2024 Annual Site Inspection

Defense Depot Memphis, Tennessee
U.S. EPA I.D. Number TN4210020570

Final
March 2025

Responses to:
U.S. Environmental Protection Agency (EPA) Region 4 Comments on:
Draft 2024 Annual Site Inspection Report Response to Comments
Defense Depot Memphis, Tennessee
Dated December 2, 2024
Comments Received January 17, 2025

Memphis Depot Industrial Park

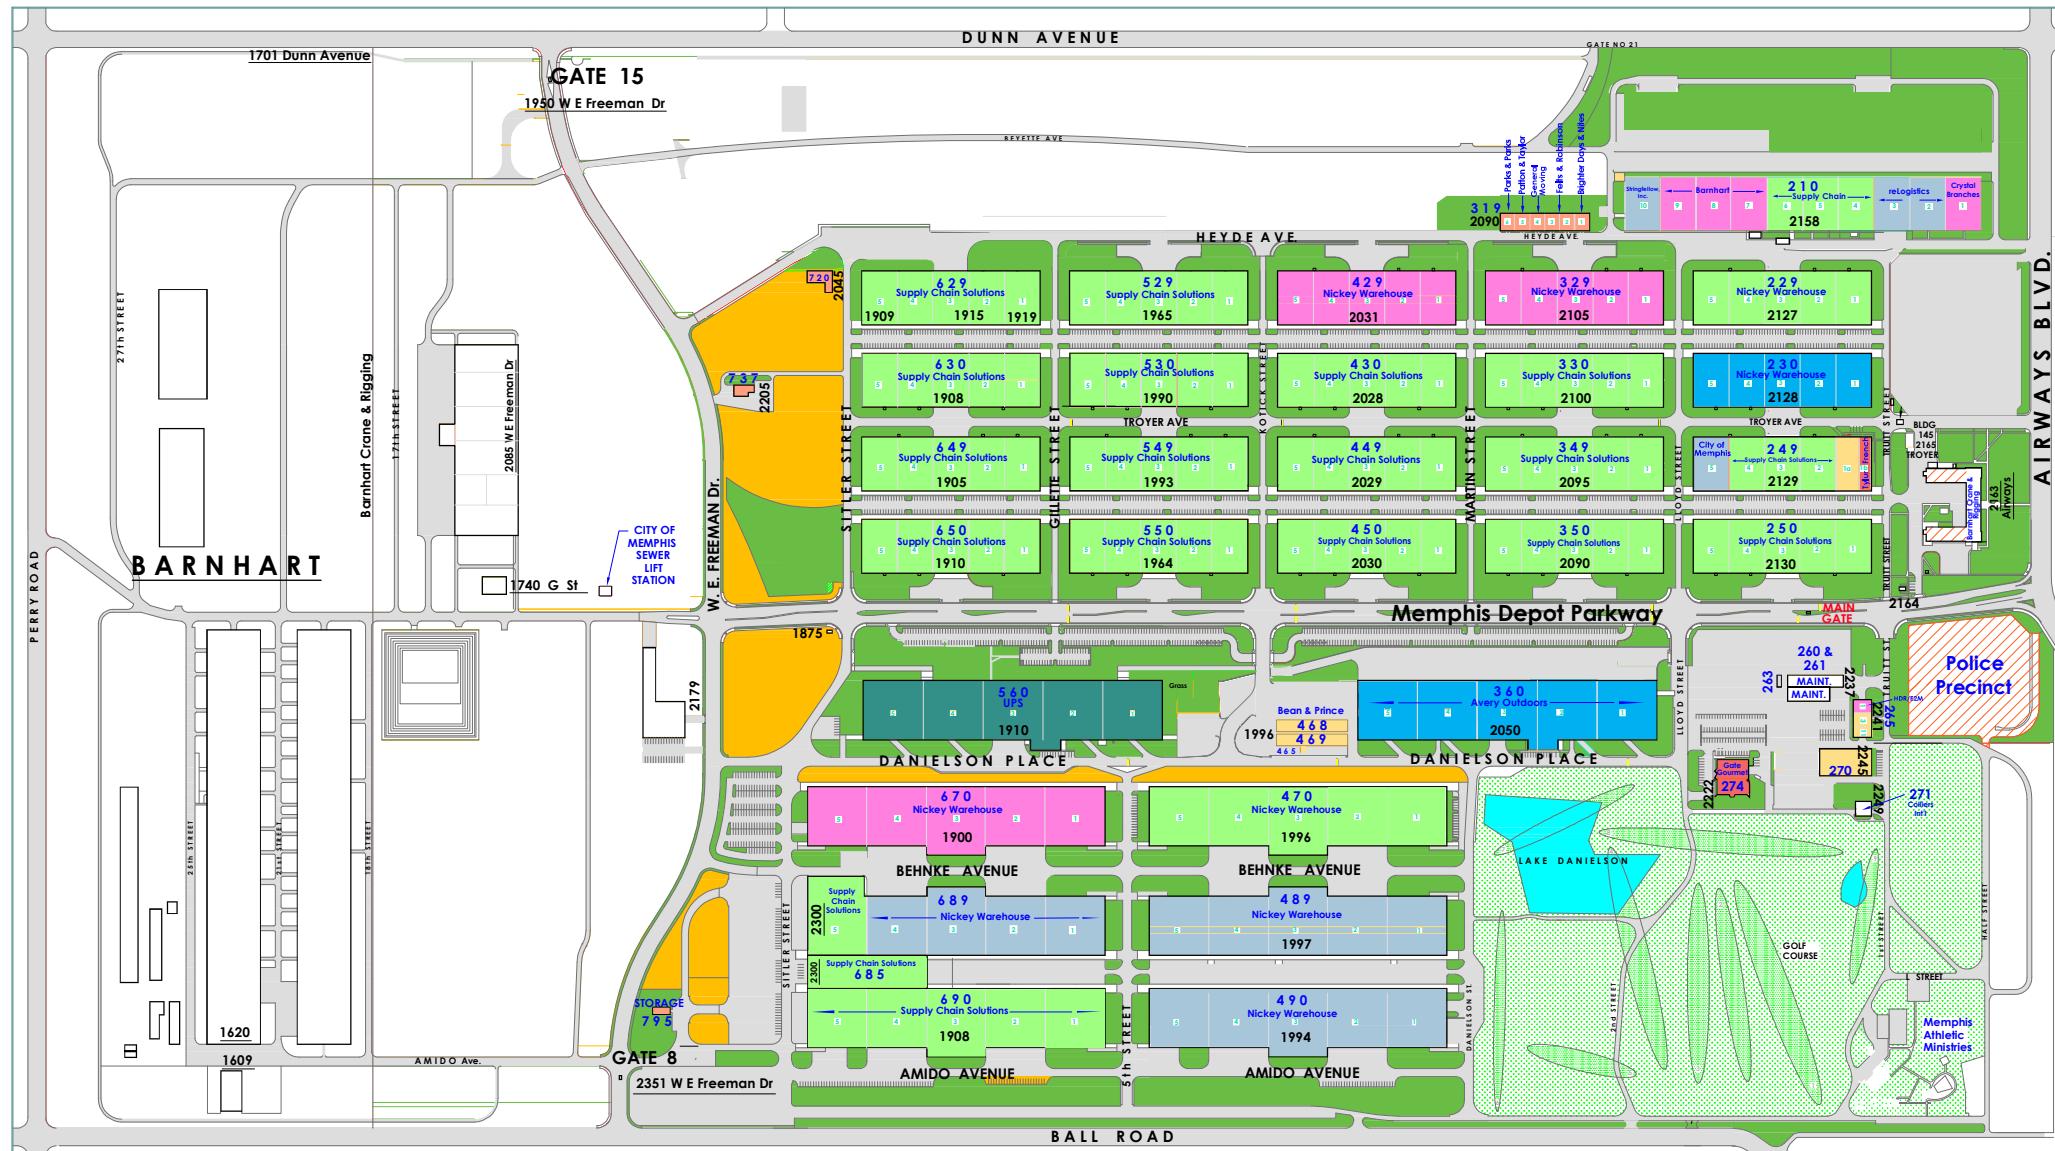
- 4. Appendix E, Memphis Depot Industrial Park Tenant List and Ownership Map, PDF Pages 47 and 48:** It is unclear where the Alpha Omega housing area is located on the Appendix E figure of tenant locations. The Alpha Omega housing area is mentioned in the Contact Records of Cindy Forsythe, David Dingeldein, Leonard Perkins, and Sean Pedigo and in a photograph included in Appendix B (Site Photographs, May 29 and June 5, 2024); however, the location is not shown on the figure of tenant locations. Furthermore, it is unclear if the owner of this housing development is included in the current tenant list. Please revise the Appendix E tenant list and the Appendix E figure of tenant locations to identify the Alpha Omega housing area.

Response S4: The Alpha Omega housing area is located on the parcel east of the Golf Course (Figure 1), within the area available for Unrestricted Use. This property was transferred to Alpha Omega Veterans Services in 2001, is not within the Memphis Depot Industrial Park and therefore not listed on the current tenant list. Figure 1 can be updated to identify the Alpha Omega Housing area, Memphis Police precinct and Barnhart Crane administrative building with the Unrestricted Use area.

4-Mile Radius of 2163 Airways Blvd

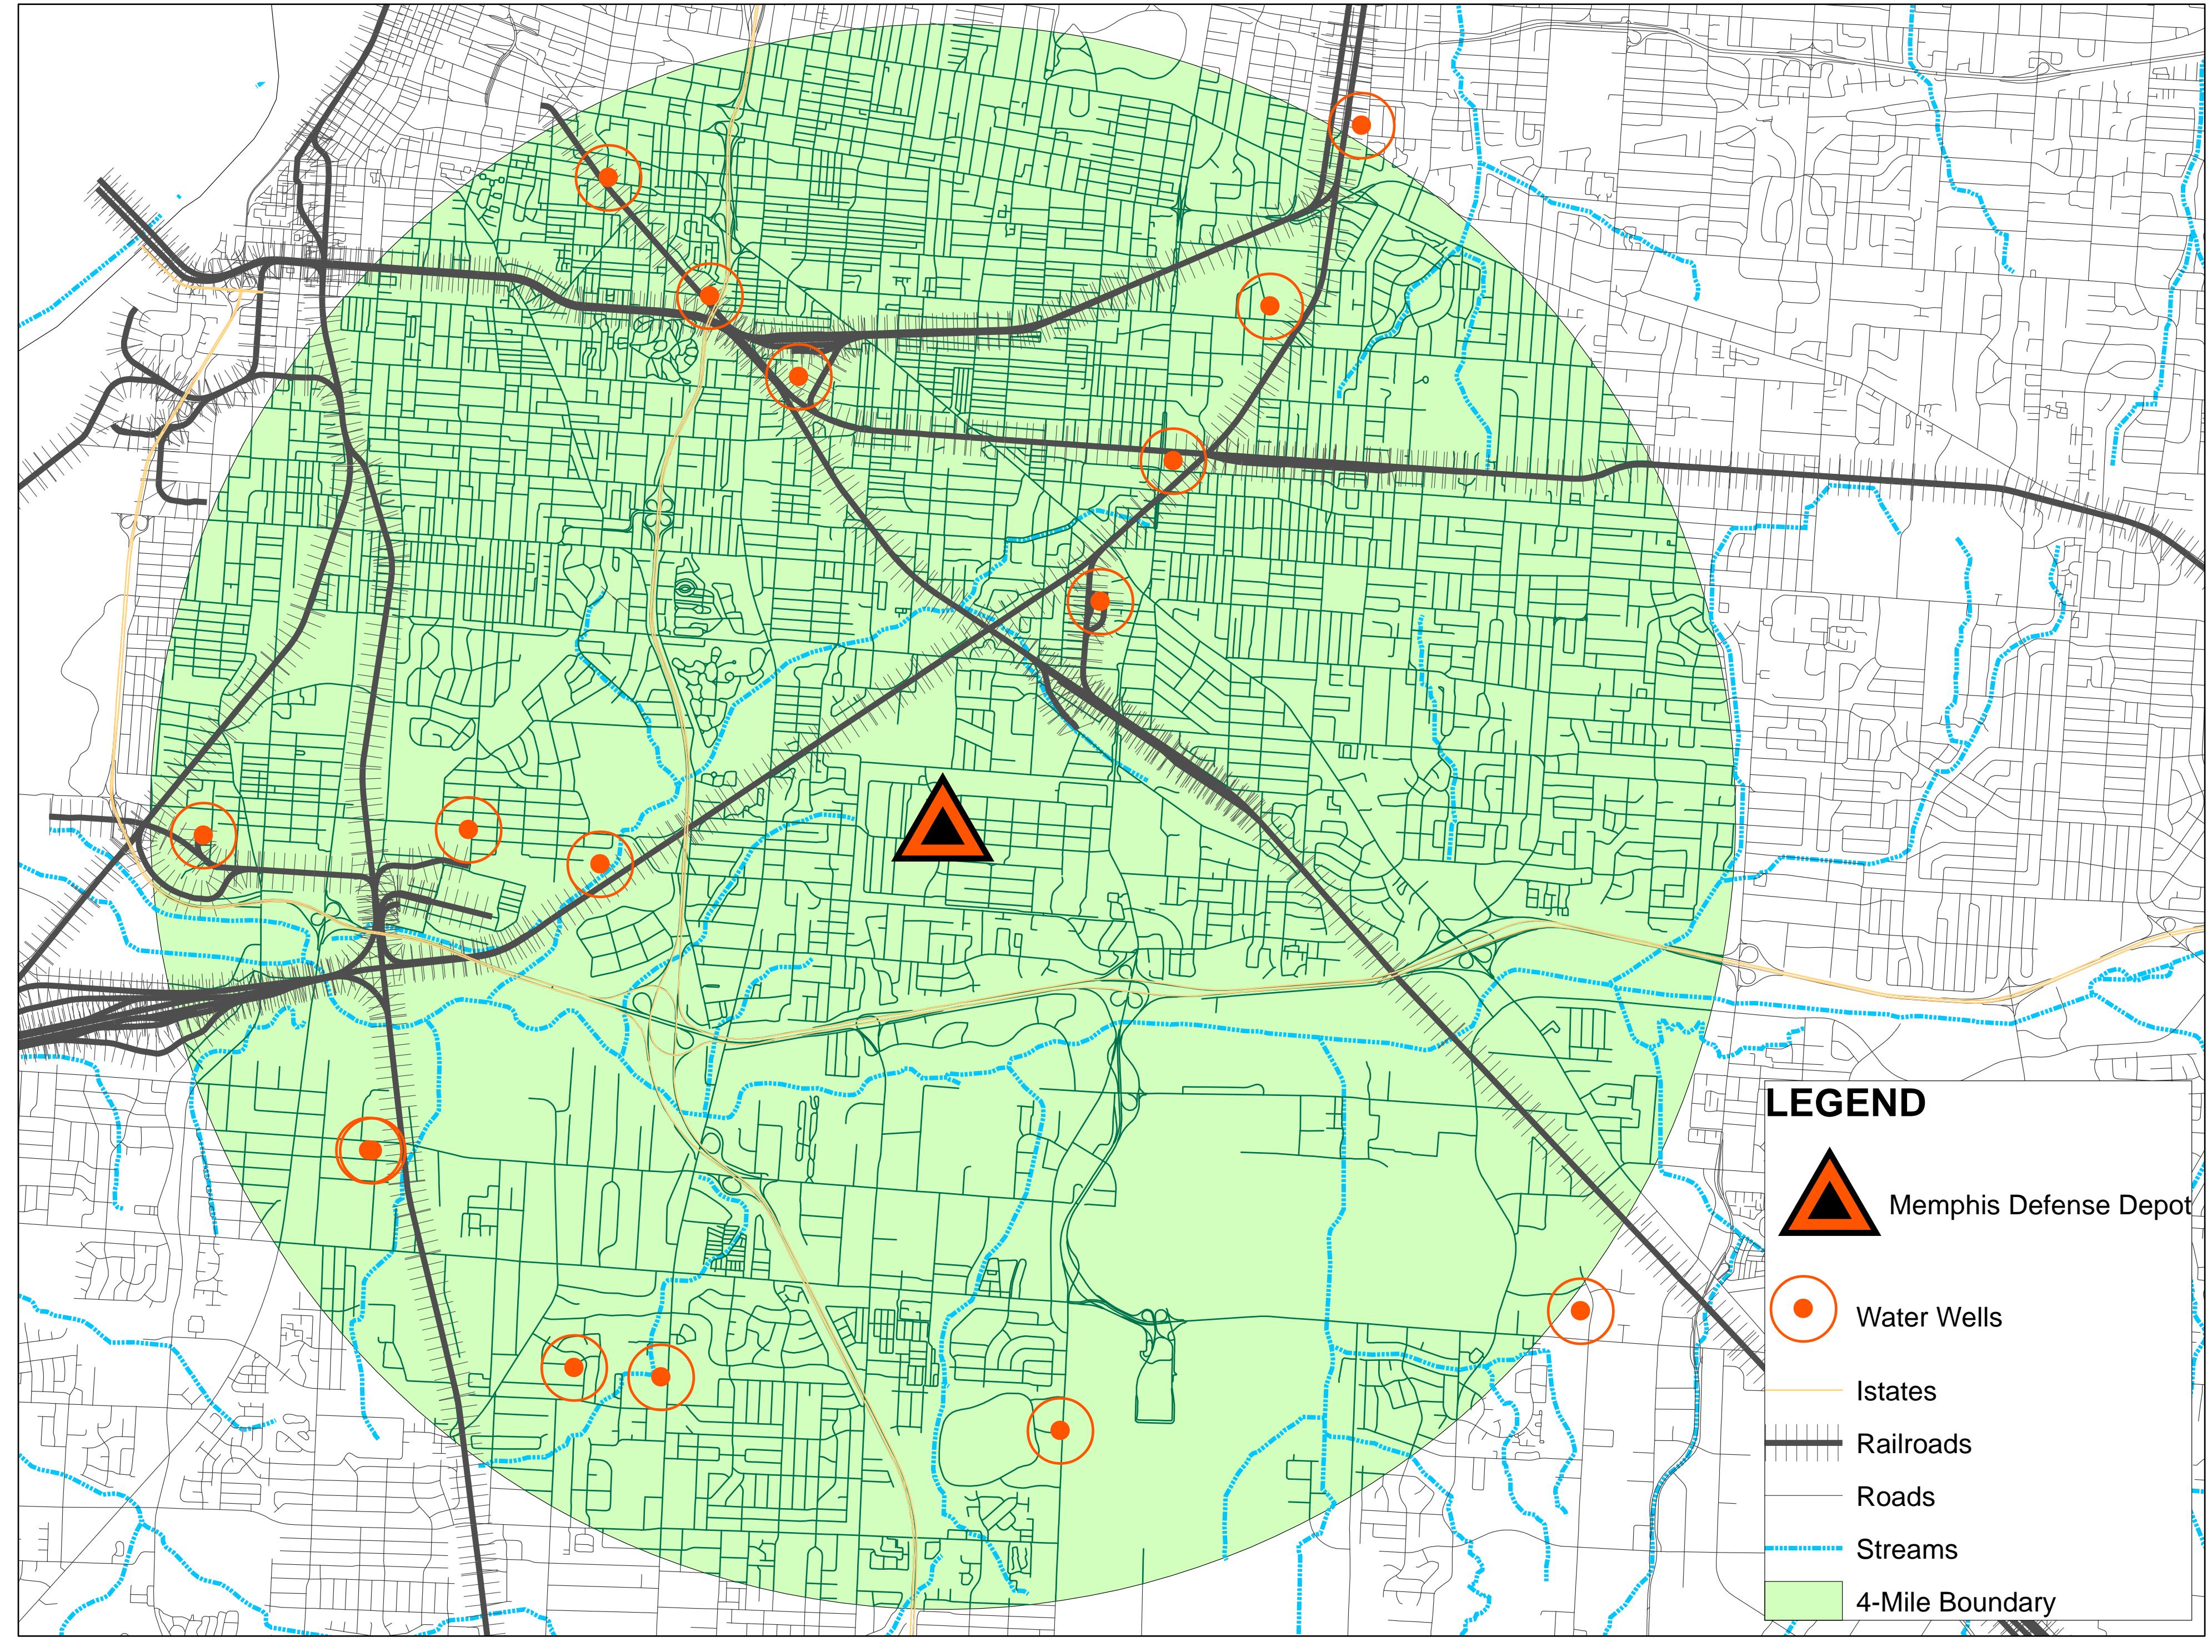
5. **Appendix F, Water Well Search, Appendix F1, SCHD Well Search Results, PDF Page 52:** The water well search map illustrates a 4-mile radius from the center point of 2163 Airways Blvd. (Barnhart Crane and Rigging); however, the title shown on Appendix F1 states a half-mile radius is shown. Please revise the Appendix F1 figure title to show both the $\frac{1}{2}$ mile and 4-mile radio.

5. **Appendix F, Water Well Search, Appendix F1, SCHD Well Search Results, PDF Page 52:** The water well search map illustrates a 4-mile radius from the center point of 2163 Airways Blvd. (Barnhart Crane and Rigging); however, the title shown on Appendix F1 states a half- mile radius is shown. Please revise the Appendix F1 figure title to show both the $\frac{1}{2}$ mile and 4-mile radio.

2. Comment for Response S5: Please provide an update on the status of obtaining the revised Figure F-1 from SCHD to correct the typographical error in the radius description.

Comment S2: Please provide an update on the status of obtaining the revised Figure F-1 from SCDH to correct the typographical error in the radius description.

Response S5: Figure F-1 was provided by the SCHD and the title referencing a $\frac{1}{2}$ mile radius appears to be a typographical error. A revised figure was requested from SCHD to correct this error.

Updated Figure F-1 is attached.
